Comments on the Pacific NorthWest LNG Environmental Impact Statement and Environmental Assessment Certificate Application

B.A. Faggetter, Ph.D. Oceanography, R.P.Bio.

(supported by the Prince Rupert Environmental Society, the T. Buck Suzuki Foundation, and the United Fishermen and Allied Workers Union - UNIFOR)

Figure 1. Extent of eelgrass as observed by Borstad Associates Ltd. as compared to the proponents' data.

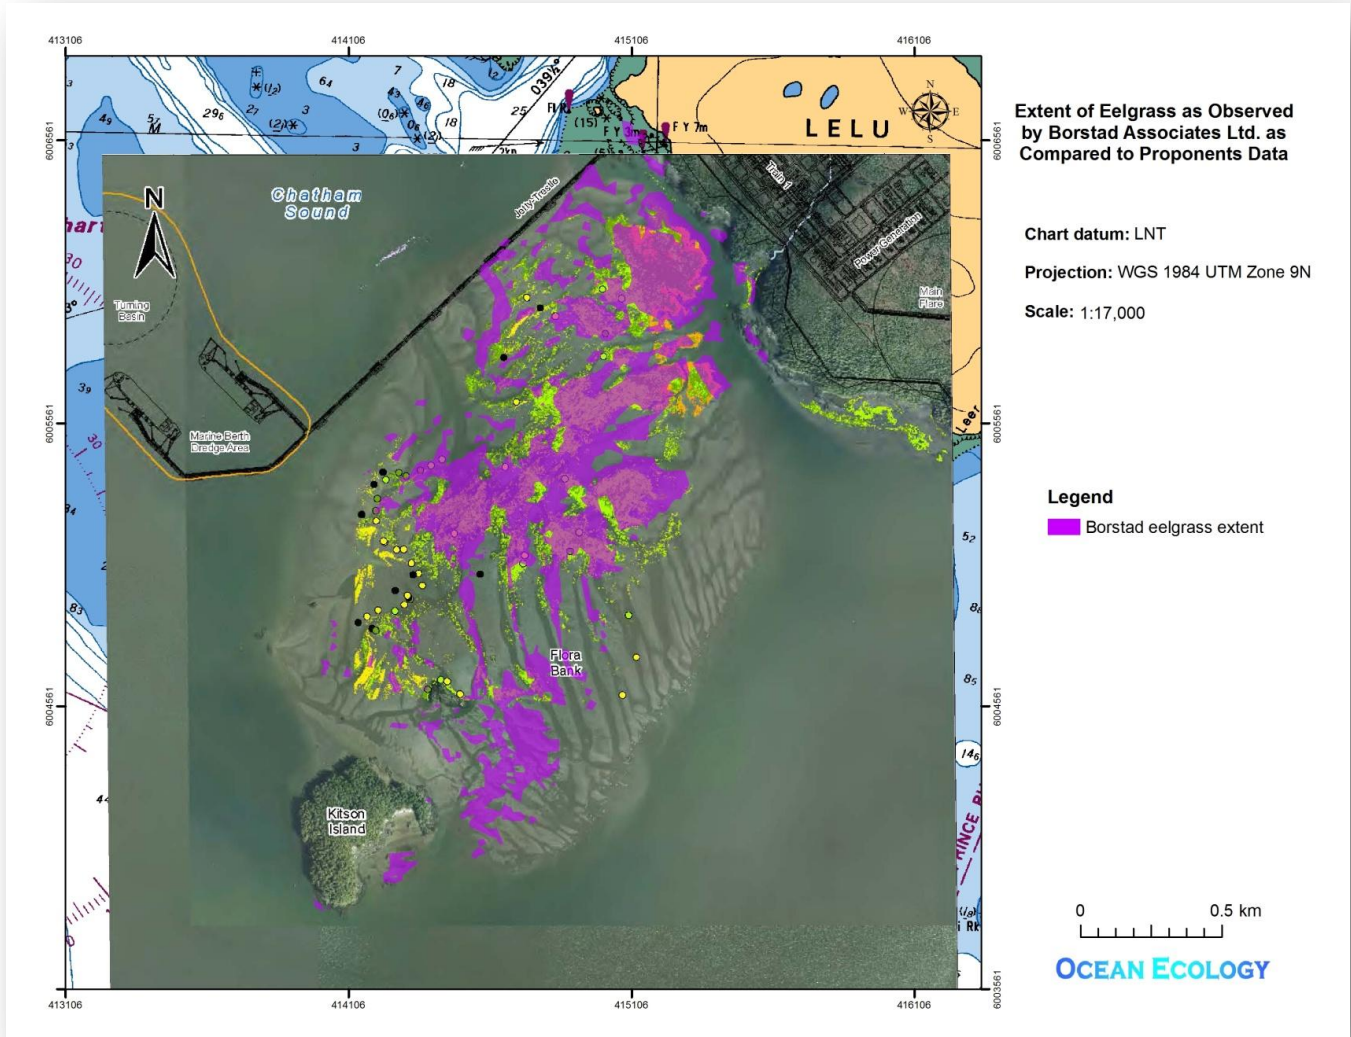
A further examination of previous surveys of Flora Bank is merited. Figure 1 shows an overlay of the data from the Borstad Associates Ltd. CASI survey done in 1997 (Borstad Associates Ltd. 1996, Forsyth *et al.* 1998) on the proponents' data. The total areal extent of the eelgrass from this survey, as calculated by myself (Faggetter 2009b), was 0.8 km². Of particular note are the eelgrass patches that extend along and under the proposed trestle. These patches do not appear in the proponents' data. In 2009, I surveyed eelgrass on Flora Bank (Faggetter 2009b). This data is shown in Figure 2 overlaid on the proponents' data. As with the proponents' surveys, this data was collected during May, and does not represent the annual maximum extent of eelgrass for the area. However, while this survey was quite limited in nature, it illustrates two important factors: (1) using a methodology designed to be effective under low visibility, high current situations, eelgrass was observed subtidally, in several cases beyond the perimeter defined by the proponents' subtidal delineation; and (2) eelgrass was observed below the proposed trestle location.

Figure 4. Areal extent of eelgrass on Flora Bank based on the aerial survey conducted on June 24, 2013.

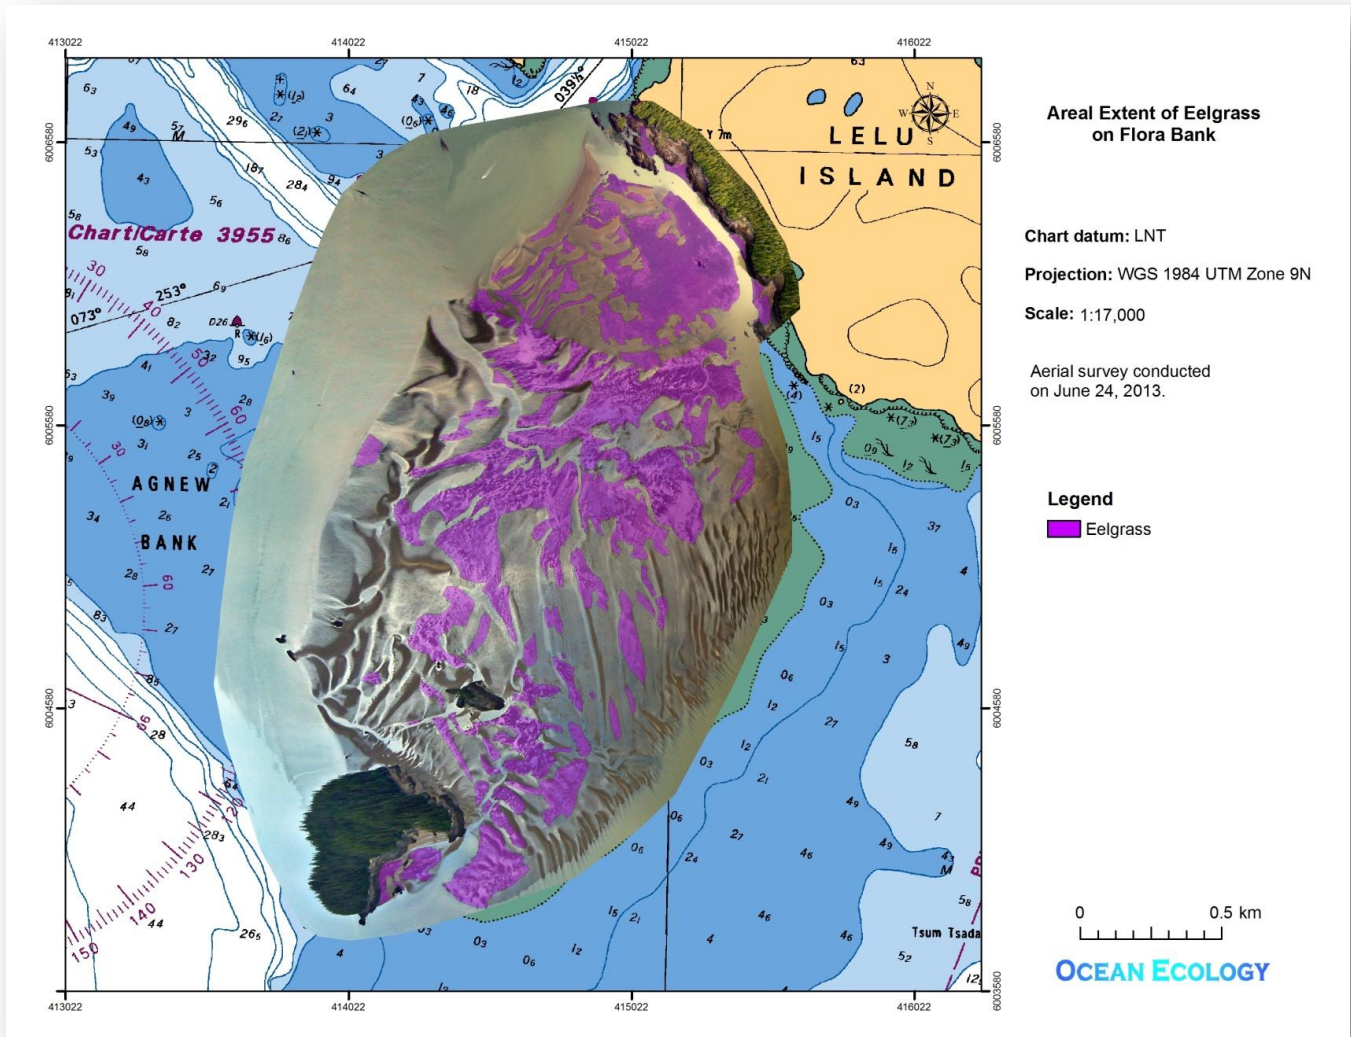
it was not possible to carry out a maximum likelihood classification. However, as a person with significant experience in both eelgrass surveys and remote sensing technology, I was readily able to identify the eelgrass based on color and texture, and hand digitized the patches (see Figure 4). No attempt was made to differentiate the eelgrass patches based on density. It was clear from the photo that eelgrass on the outer edges of Flora Bank had not yet reached its maximum growth for the season (e.g., the eelgrass was still short and "shrubby", rather than forming long, flat-laying swaths). This is not unexpected, as the eelgrass on the outer edges occurs at greater depths and receives less total sunlight annually, thus reaches its maximum growth later than eelgrass at the center of the bank. Based on this data, I estimated the total areal extent of the Flora Bank eelgrass bed at 1.0 km². As with the proponents' data, this estimate does not likely represent the maximum extent, which would occur later in August. However, it is still significantly larger (56%) than the amount (0.64 km²) used by the proponent in their report (see Figure 5). The extent of the eelgrass seen in this survey also agrees well with the Borstad Associates Ltd. CASI survey done in 1997 (Borstad Associates Ltd. 1996, Forsyth *et al.* 1998; see Figure 6). Of particular note, the large patch of eelgrass present to the northeast of Kitson Island in 1997, which did not appear in the 2011 WorldView-2 satellite image, is present in the 2013 aerial survey. However, the 2013 aerial survey was not able to confirm the presence of the bed of eelgrass along the southwestern aspect of Lelu Island near Leer Point, which was detected in 2011 WorldView-2 satellite image, due to lack of coverage at this location. Finally, it is important to note that there is eelgrass present under the proposed trestle based on the data from the 2013 aerial survey (see Figure 7). The amount of this impacted eelgrass is 14,295 m² - approximately 15 times more than the proponents' estimated 935 m².

Figure 7. Eelgrass impacted by the proposed trestle based on the 2013 aerial survey.

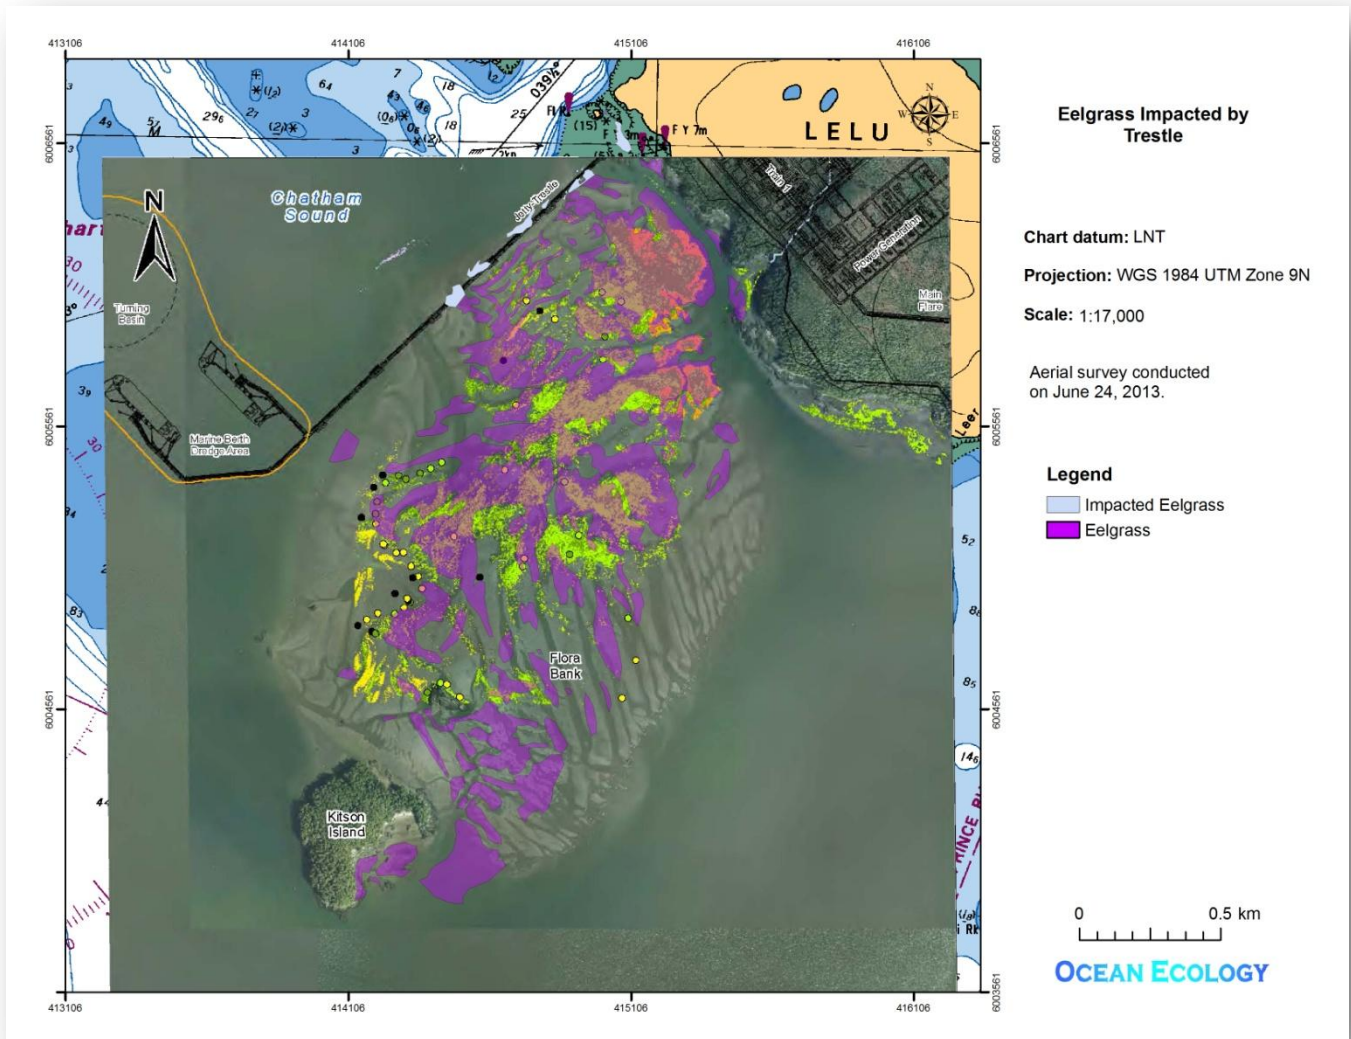
- 1) Significant patches of eelgrass growing in the area of the proposed trestle were missed by the proponents' surveys. This eelgrass will be severely impacted by the project and needs to be included in the discussion on impacts and mitigation.

Figure 8. Habitat suitability index calculated for juvenile pink salmon (an epibenthic species).

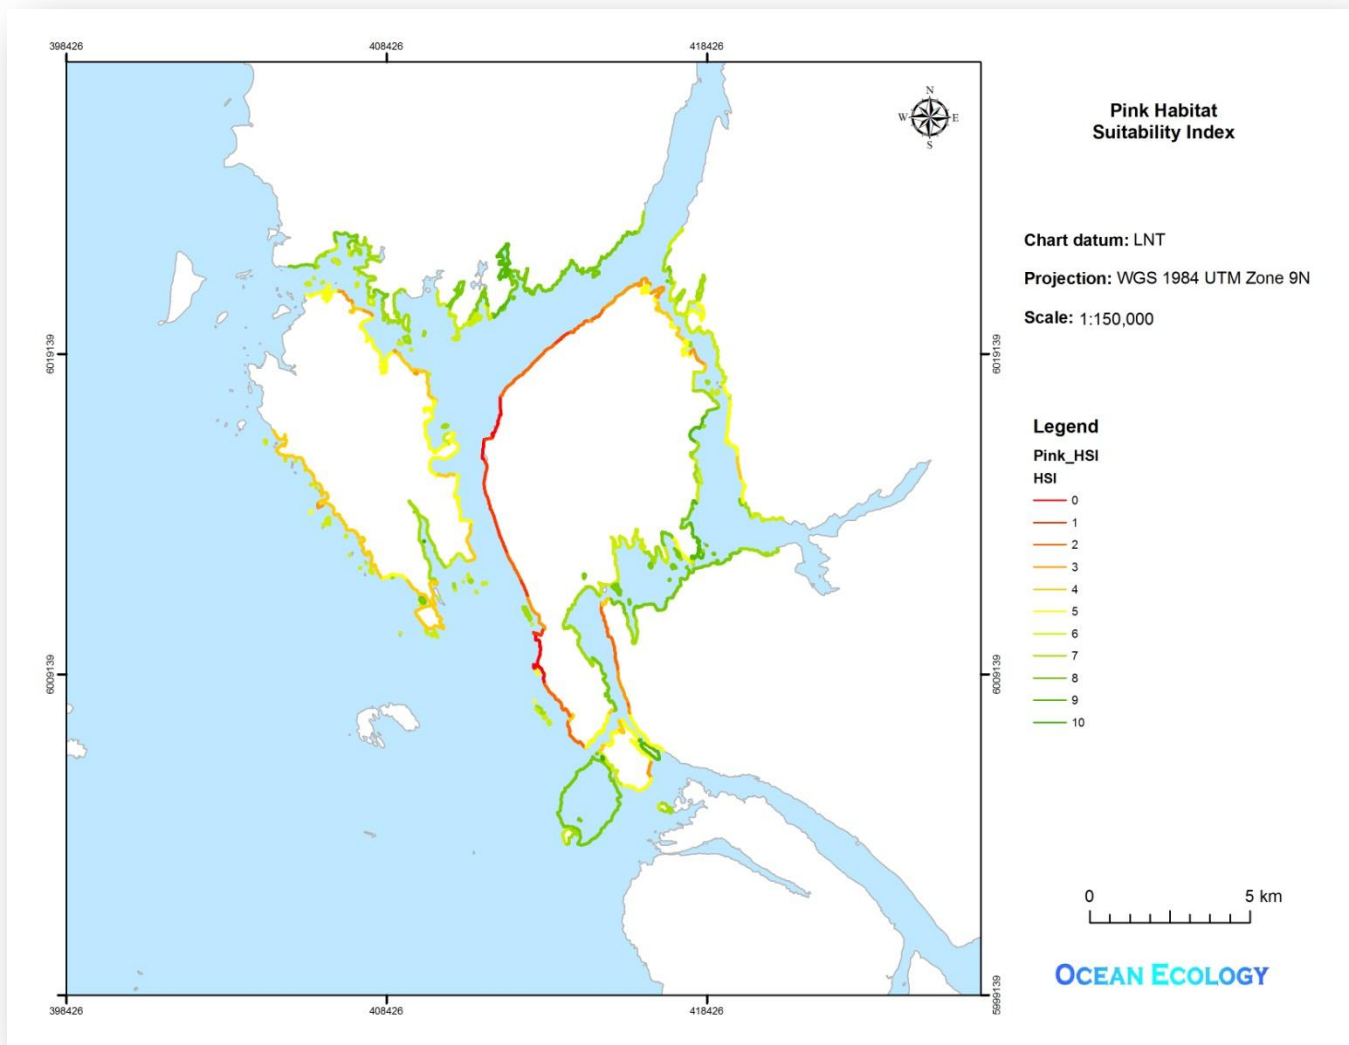
To fully understand the importance of an HSI value of 8, it is necessary to consider the HSI values assigned to other nearby locations. Porpoise Channel has an HSI value of 4-5, the nearby Ridley Island shoreline has an HSI value of 2, and the Lelu Island shoreline has HSI values ranging from 3 to 6. Therefore, locally, in the area around Inverness Passage, Lelu Island, Porpoise Channel, and southern Ridley Island, Flora Bank has the highest HSI value, and is the best juvenile salmonid habitat in this region. In the entire study area for this research, a region which included all of Prince Rupert Harbour and the northern reaches of the Skeena River estuary, there were very few other shoreline segments which had HSI values equal to or exceeding that of Flora Bank, and these few segments were in the basins on the east side of Kaien Island and on the southern tip of the Tsimpsean Peninsula.

Figure 9. Location of the Skeena Cellulose effluent plume in relation to current and proposed industrial sites.

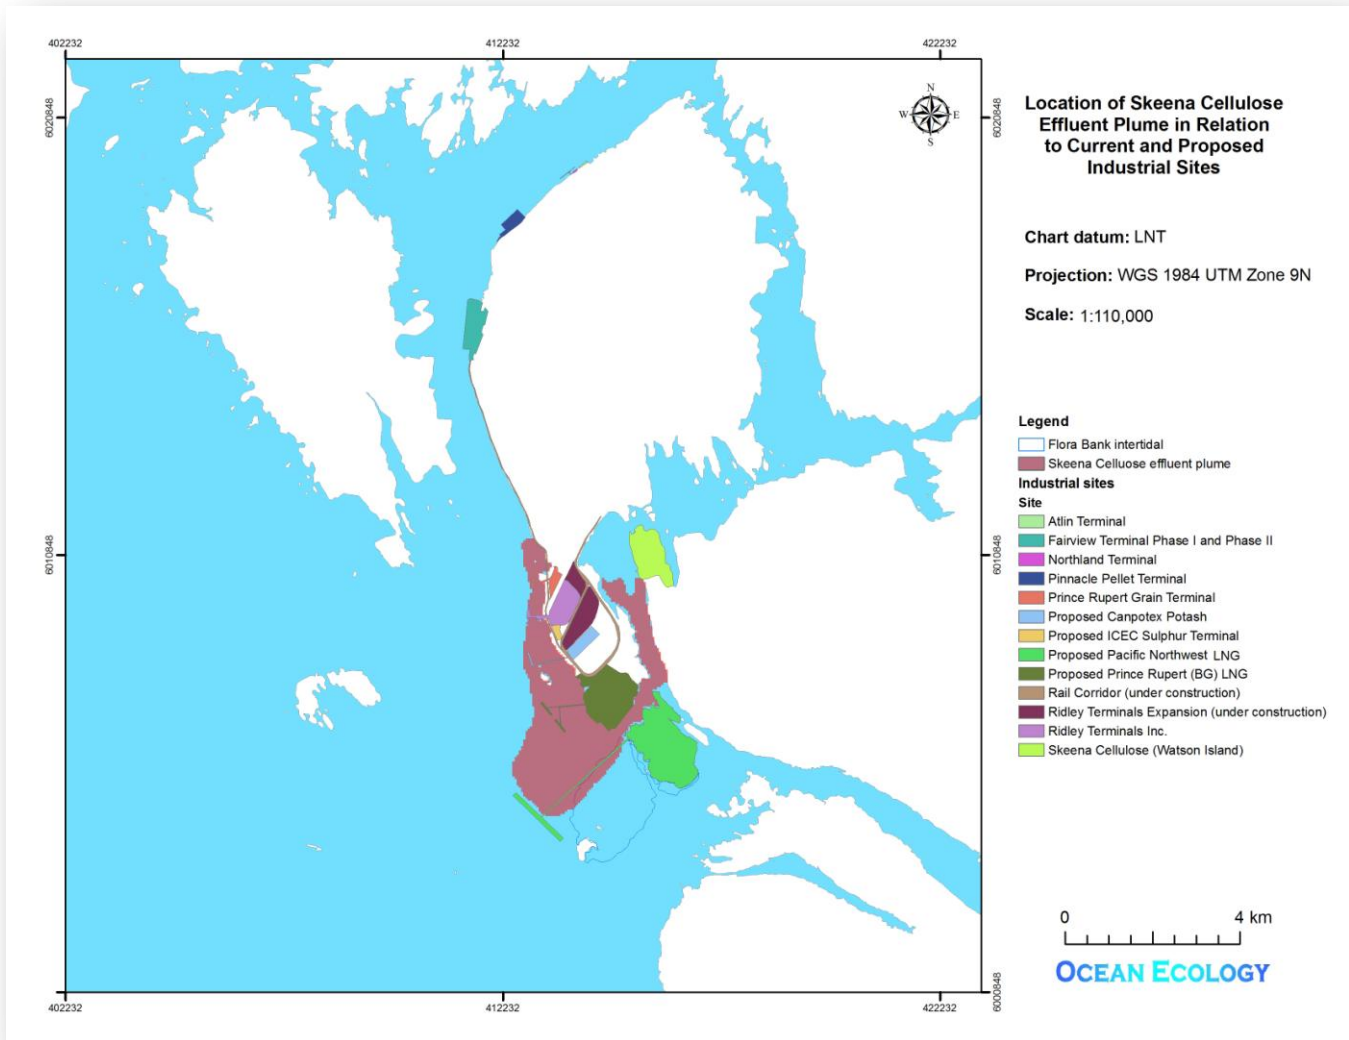
The proposed facility is within the effluent plume of the old Skeena Cellulose pulp and paper mill (see Figure 9). Consequently, the proponents will need to be concerned with the possibility that the sediments in and around their proposed facility are contaminated, particularly with dioxins and furans. The proponents have provided sediment quality data for the MOF (materials off-loading facility). However, they have not provided data regarding the nature of the sediment in the marine terminal area. Why has this data not been provided? We can assume that the marine terminal region has sediment chemistry similar to the MOF and other projects in the near vicinity; however, it is important that the sediment chemistry of this region be examined in order to confirm this. If this is indeed the case, then the following statement given by the proponents regarding the MOF could also be considered true of the marine terminal area:
